# CAMLEY STREET KINGS CROSS

Canopy to Affordable Entrance & South East Corner Amendment

29th July 2016

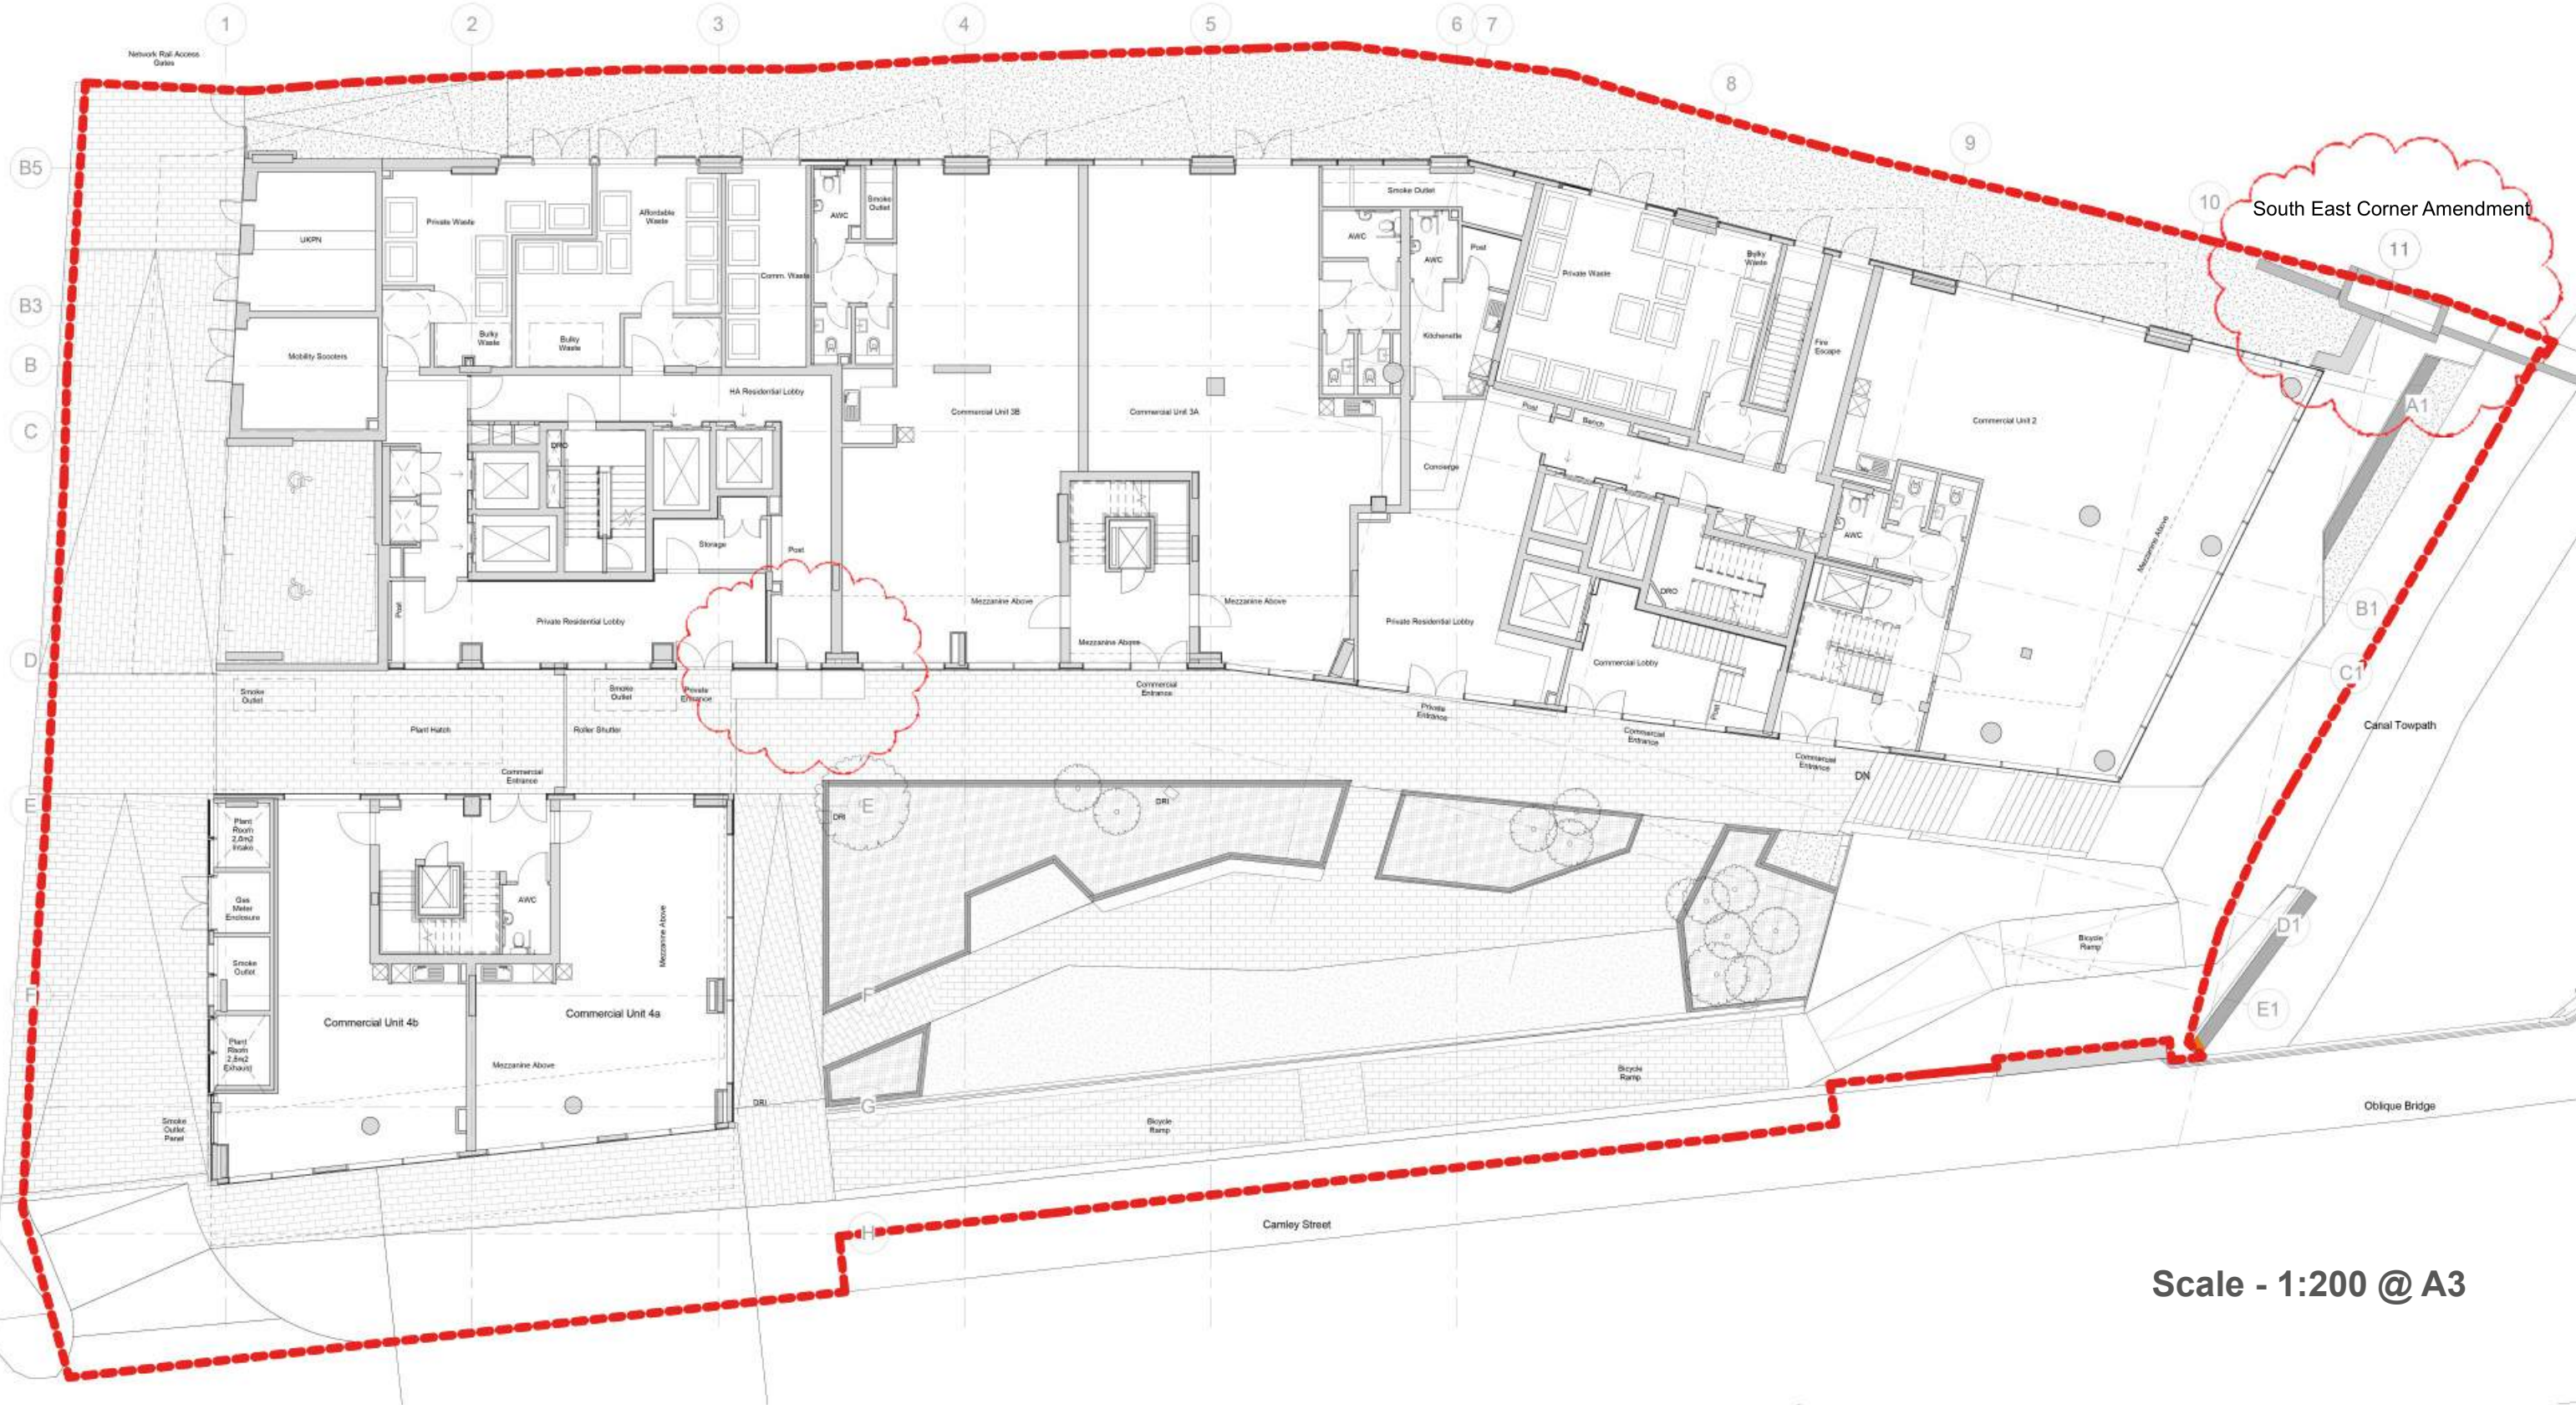
During phase 1 construction of the scheme at Camley Street unexpected sheet piling was located in the ground adjacent to the south east corner of the building and the railways abutment to HS1.

On structural investigation it became clear that removal of the sheet piling was not an option which could be considered as the implications to the railway bridge abutment could not be foreseen.

The only viable option (due to structural complications) was to change the location of the proposed RC retaining wall by moving it closer to the building.

This in turn presented issues with the build-ability of the lower ground floor and the only possible option was to amend the design of the external area which resulted in the loss of a small recess adjacent to the curtain walling of the lower ground floor office.

From a cleanliness of the site perspective this does result in a more positive design response than the original consents scheme by eliminating a small recess to the side of the building which previously had the potential for collection of refuse and possible social abuse.

## 02. Ground Floor Plan - Proposed Amendments

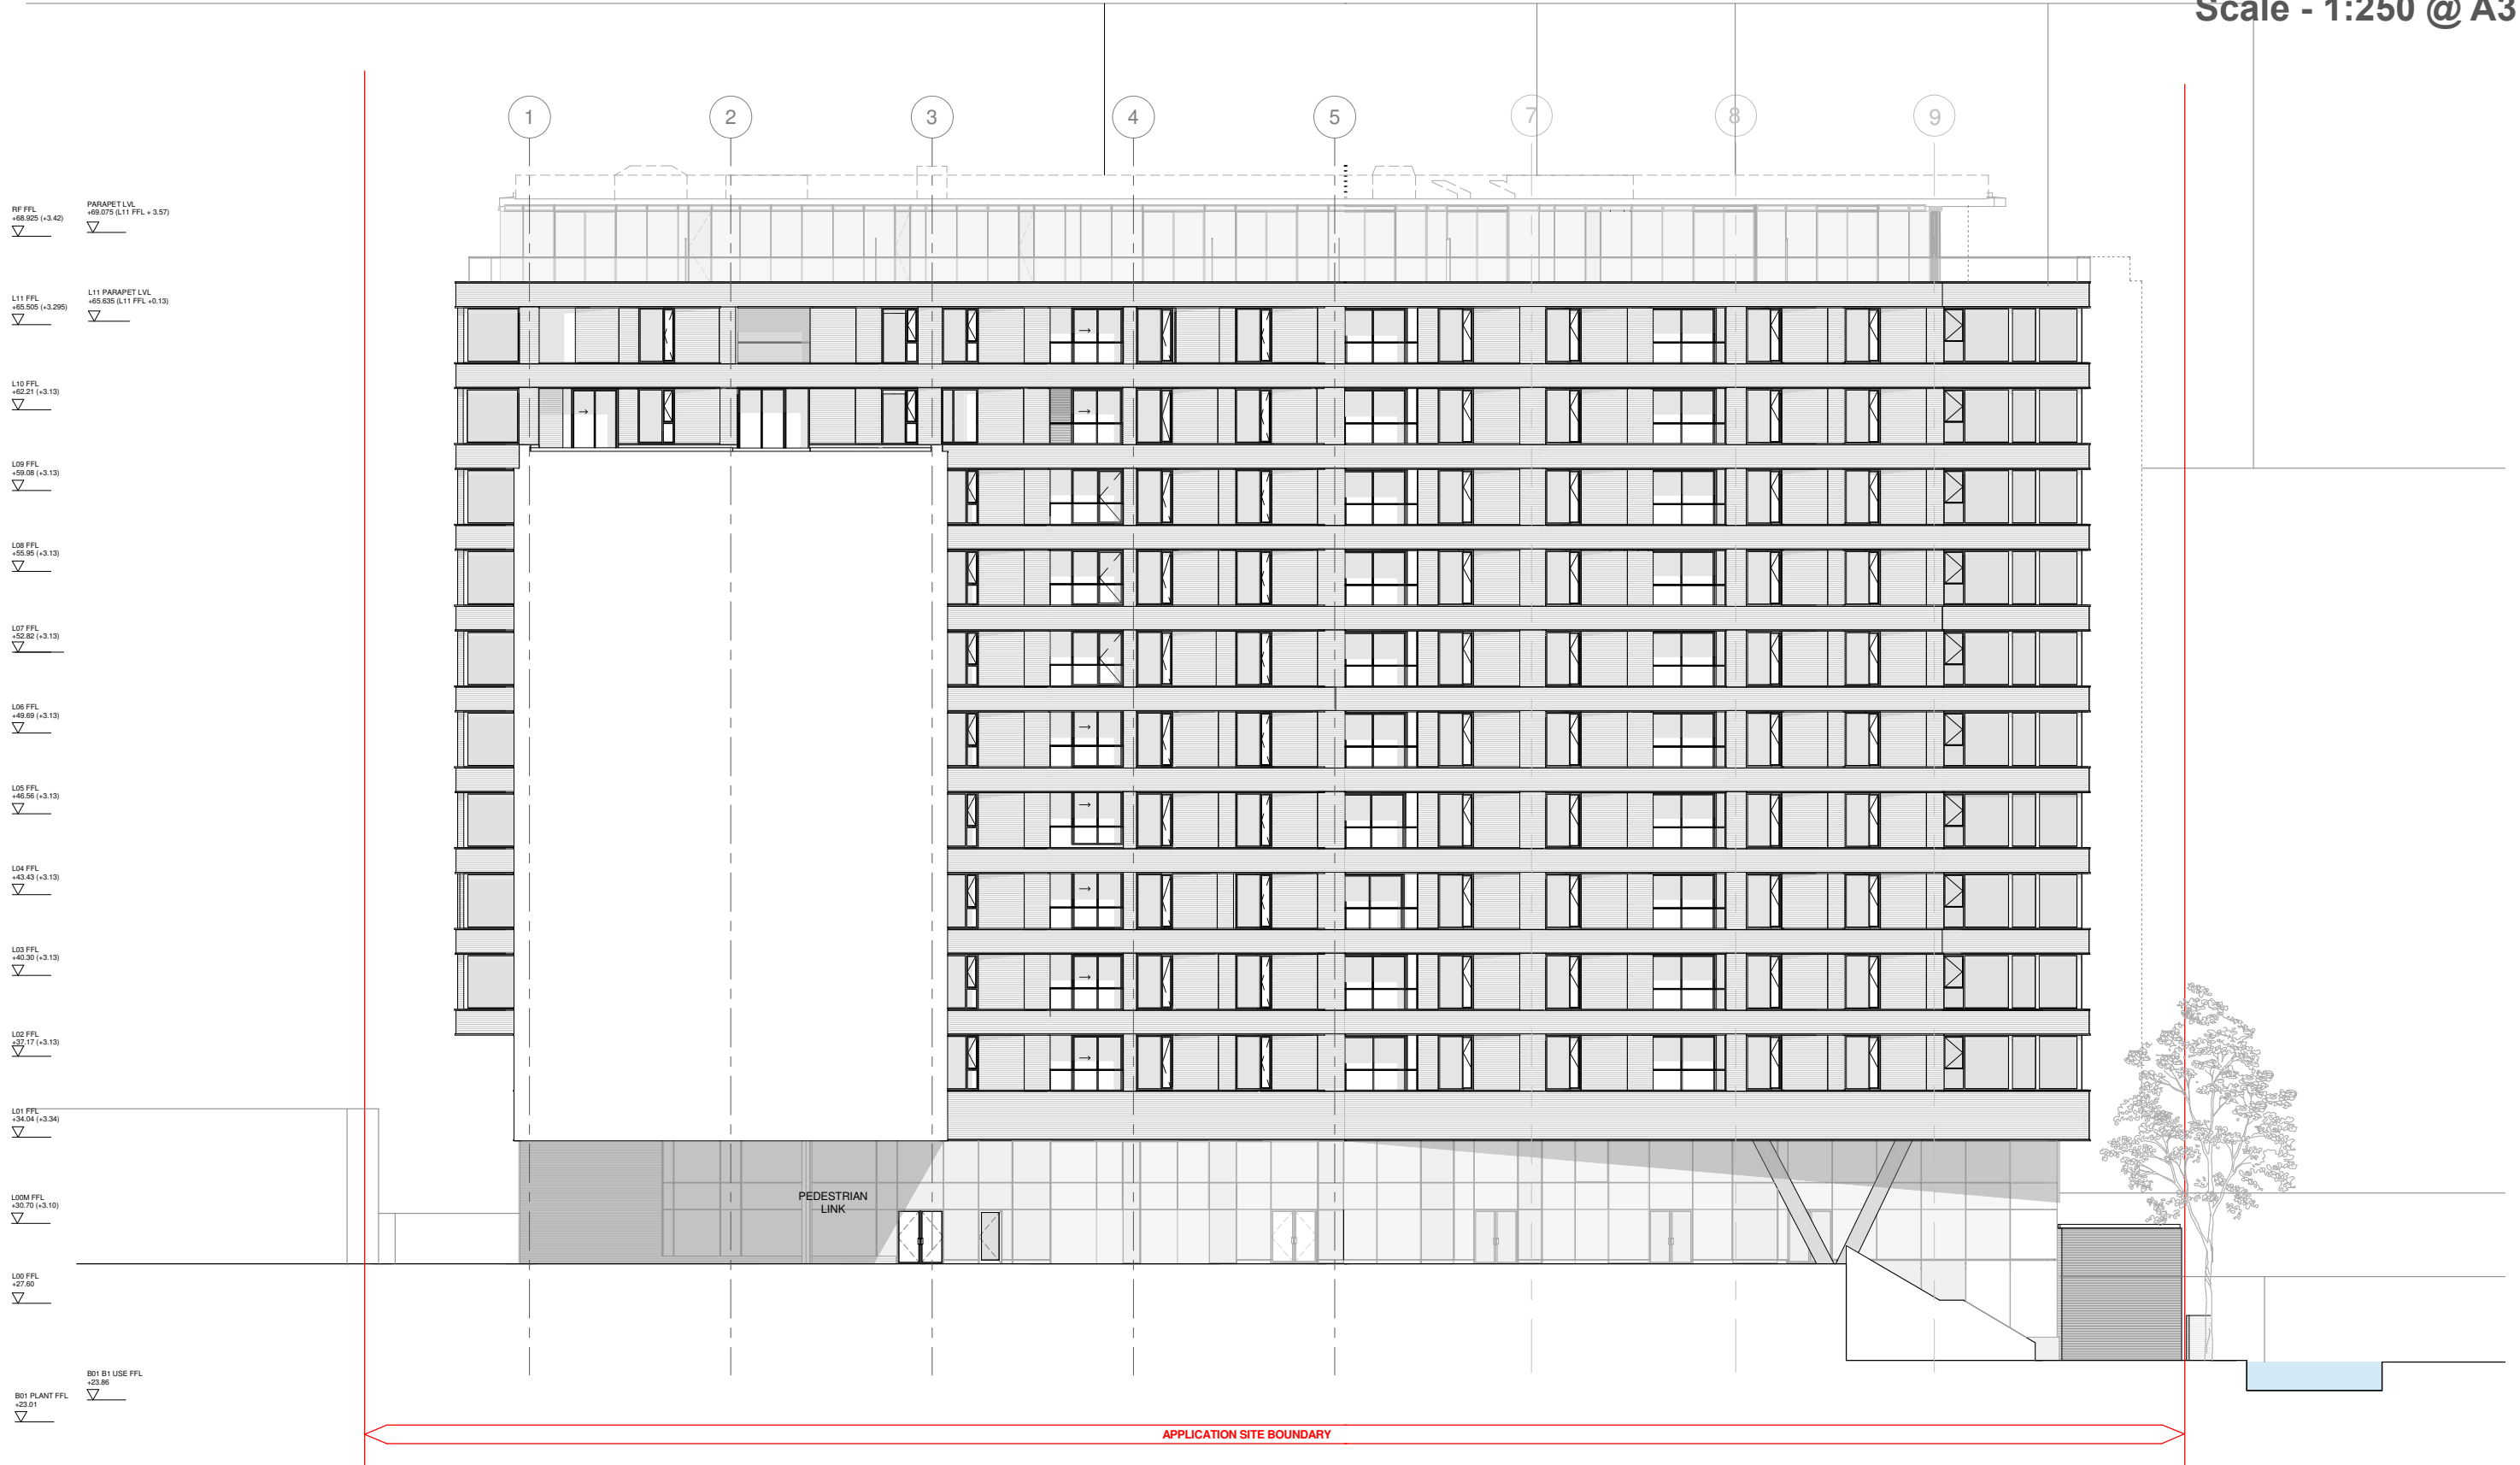
In order to comply with Lifetime Homes (LTH) the entrance to the affordable housing core must have a covered entrance to provide residents adequate weather protection. The relevant LTH criteria is

All main entrances\* should be covered to provide weather protection for those unlocking, or waiting at, the door. The size and form of the cover should have regard for local conditions to provide effective weather protection. As a general guide, the cover at an individual dwelling door should have a minimum depth of 600mm (900mm being typical). As a general guide, the cover at a communal door should have a minimum depth of 900mm (1200mm being typical). The width of the cover should exceed the width of the doorset plus any associated controls. At exposed sites additional cover and protection may be necessary.'
